### **REMARKS**

**EXHIBIT A:** Replacement Sheets for FIGS. 3 and 8

**EXHIBIT B:** Annotated Sheets showing changes made to FIGS. 3 and 8

RELATED ART  
FIG. 3

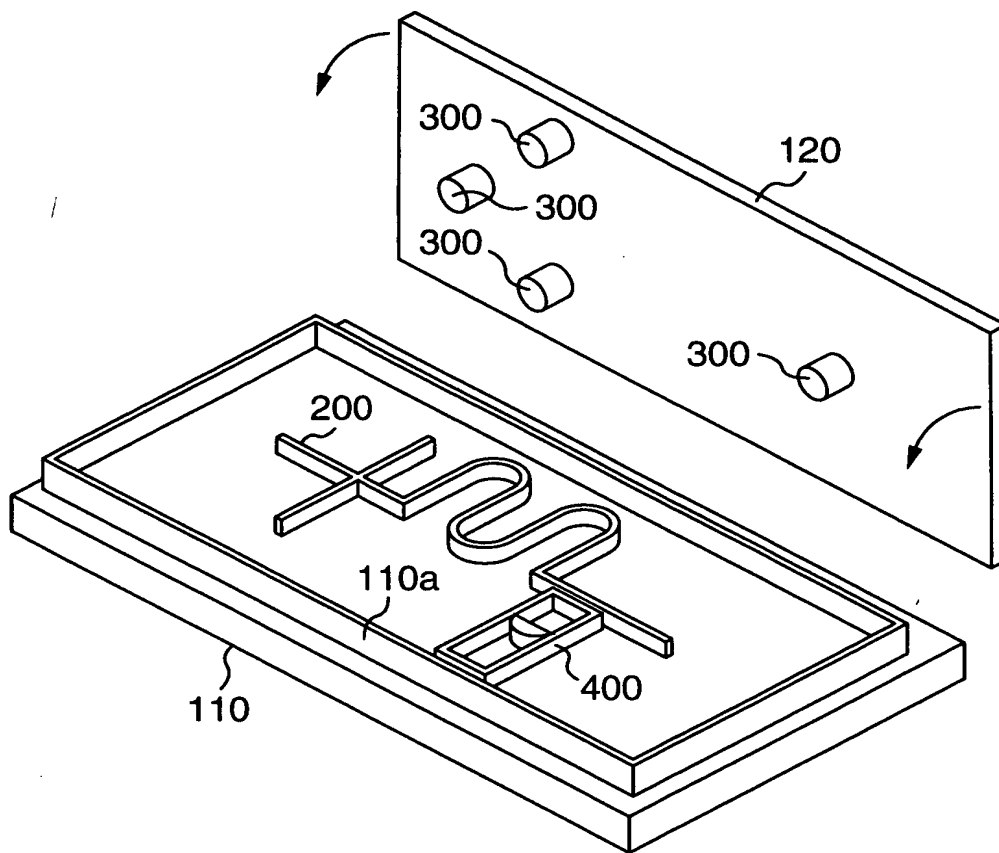
The drawings have been objected to because FIG. 3 is not designated by a legend such as "Prior Art." However, this objection is incorrect. FIG. 3 is not believed to constitute "prior art" as that term is defined by either 35 U.S.C. §102 or 35 U.S.C. §103. Rather, FIG. 3 is simply an abstract representation of the art prepared by Applicants in an effort to illustrate Applicants' discovery of problems plagued in the art; this discovery is itself, together with Applicants' abstraction of the art represented by FIG. 3, part of Applicants' invention. FIG. 3 is therefore, Applicants' work products and Applicants' effort to describe his invention in terms of both the problems which have plagued in the art and which Applicants have addressed with the inventions defined by the claims. In view of these explanations, Applicants again trust that the objection will be withdrawn. Nevertheless, for purposes of expedition, FIG. 3 has been labeled as "Related Art" in order to place the application in condition for allowance.
